RECORD DRAWING
DATE: DECEMBER 21, 2012

PROJECT NAME:	COLCHESTER CAMPUS CONNECTOR
PROJECT NUMBER:	TCSP TCSE (007)
FILE NAME: ...\\Plot Files\046-053_EPSC.pxf	PLOT DATE: 12/2/2010
PROJECT LEADER: JBL	DRAWN BY: PZA
DESIGNED BY: TFD	CHECKED BY: GGG
EPSC PLAN EPSC-4	SHEET 49 OF 153

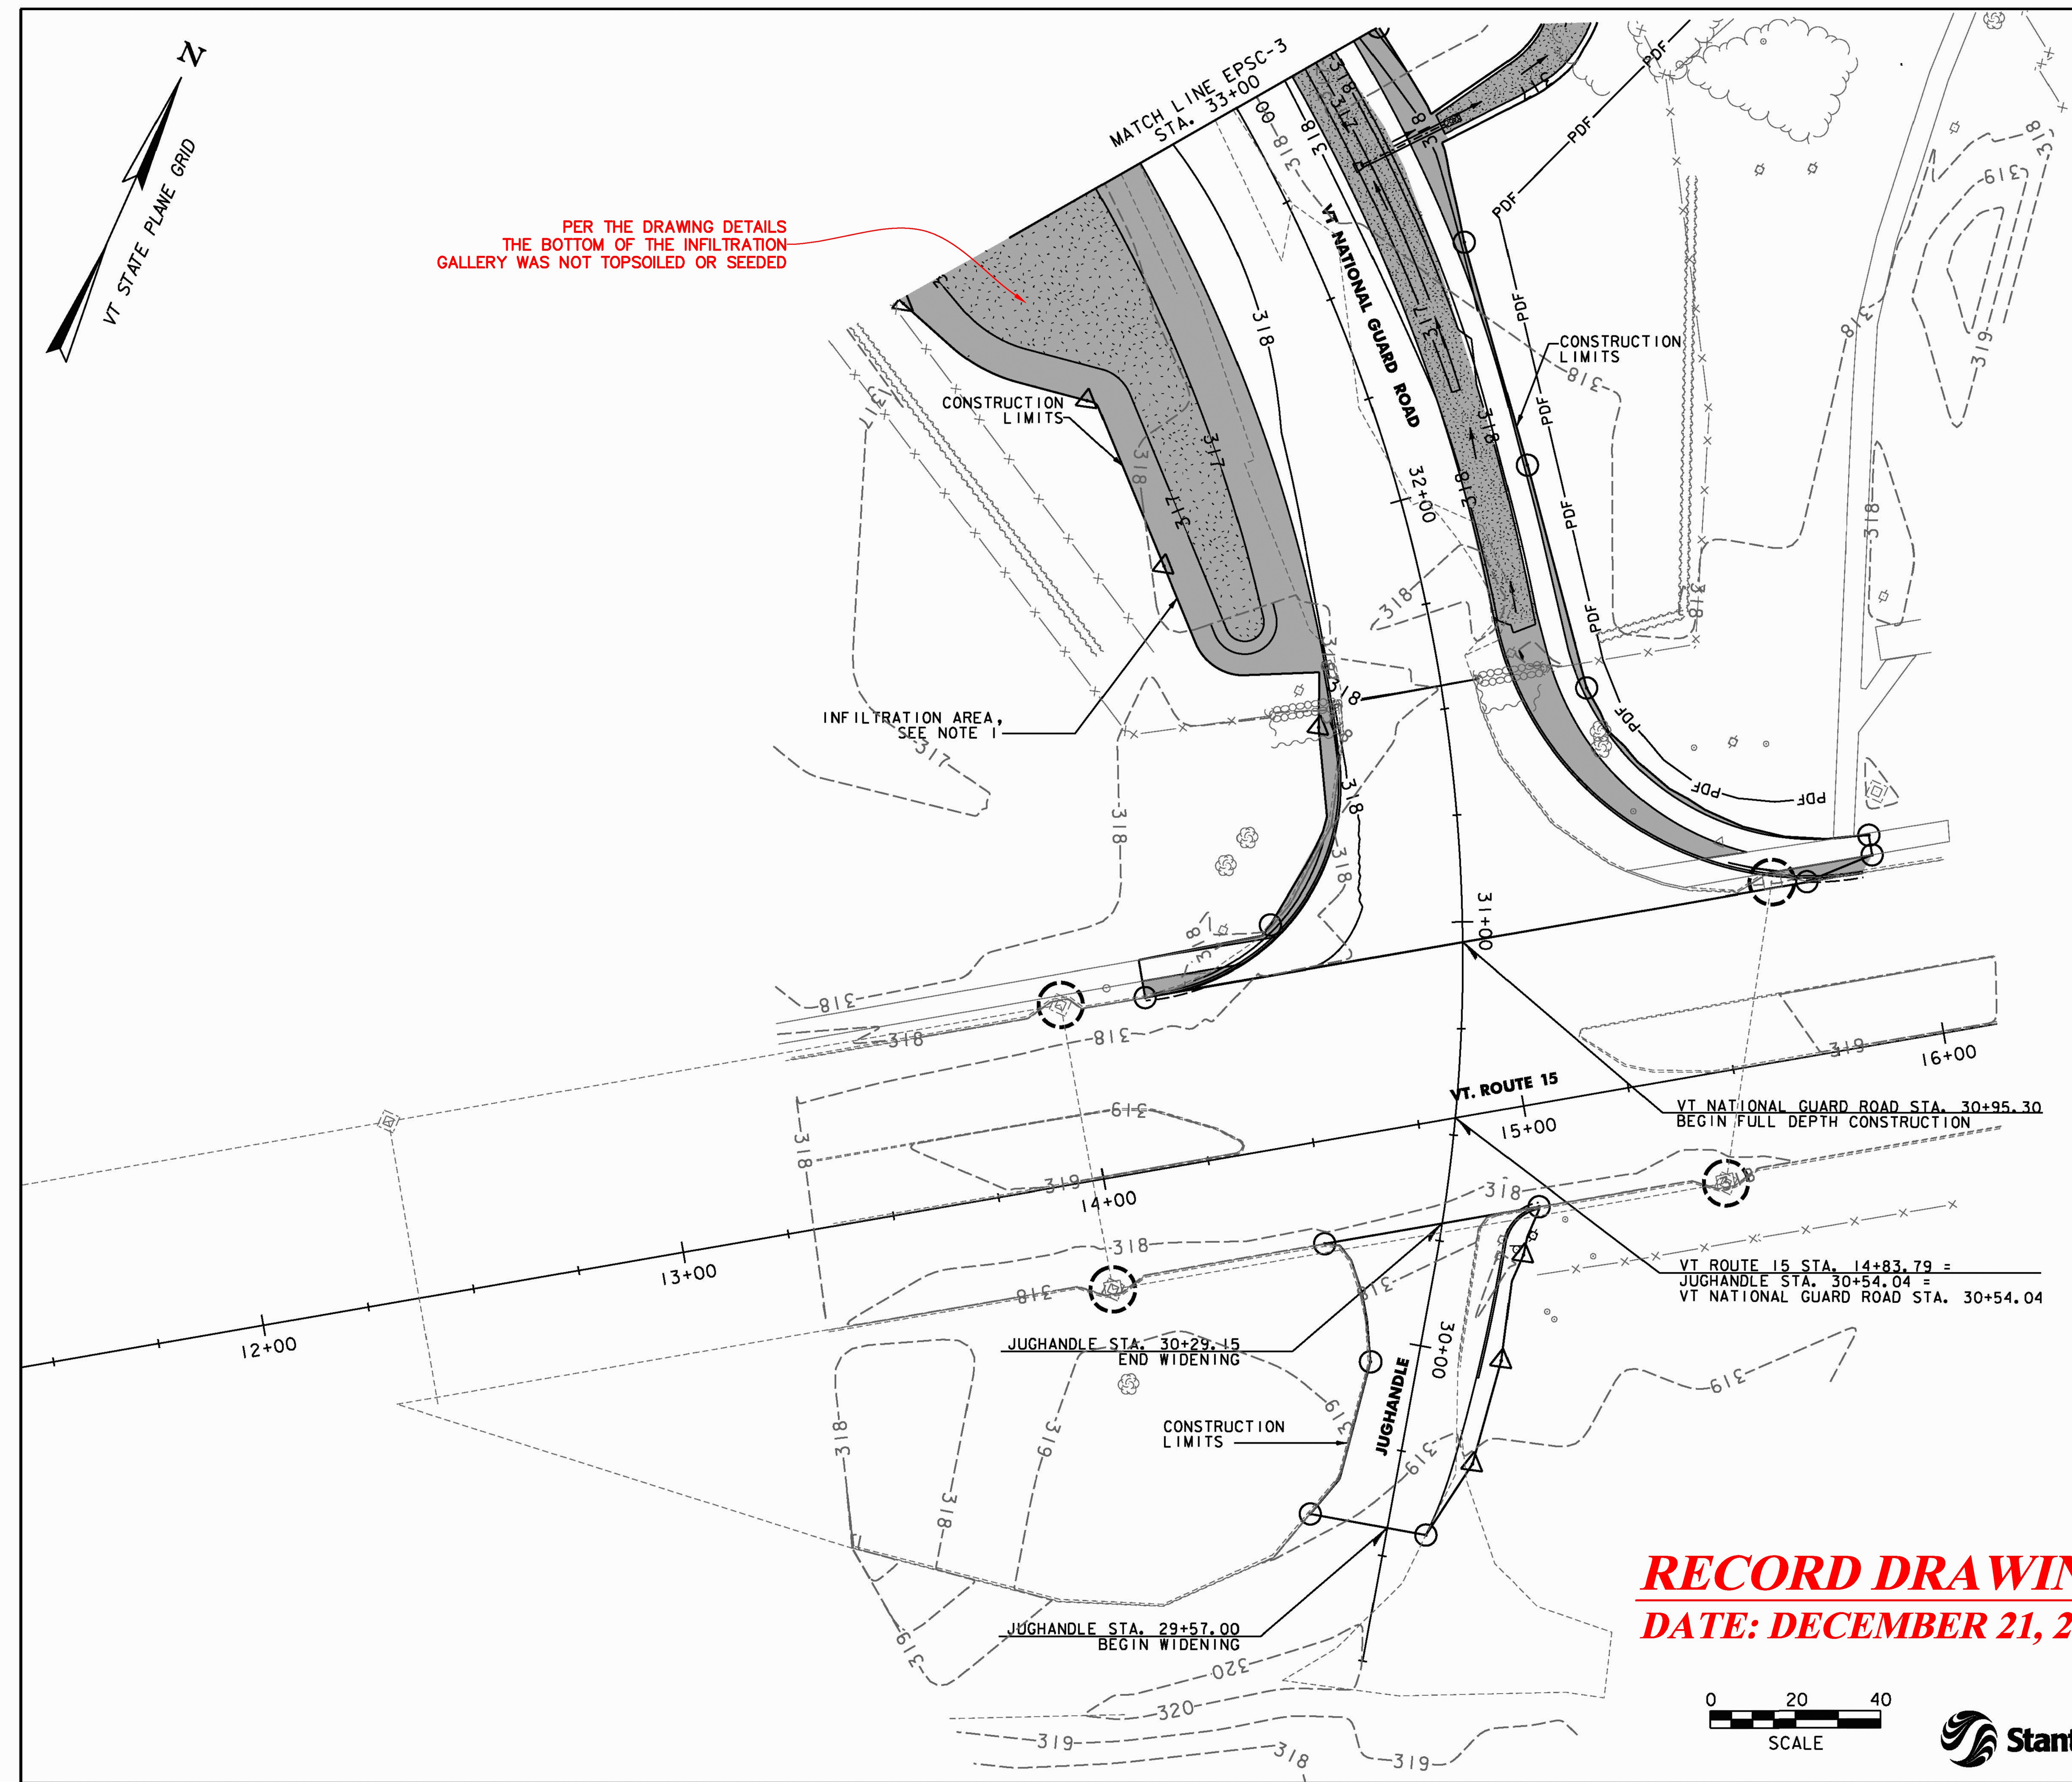
PER THE DRAWING DETAILS
THE BOTTOM OF THE INFILTRATION
GALLERY WAS NOT TOPSOILED OR SEEDED
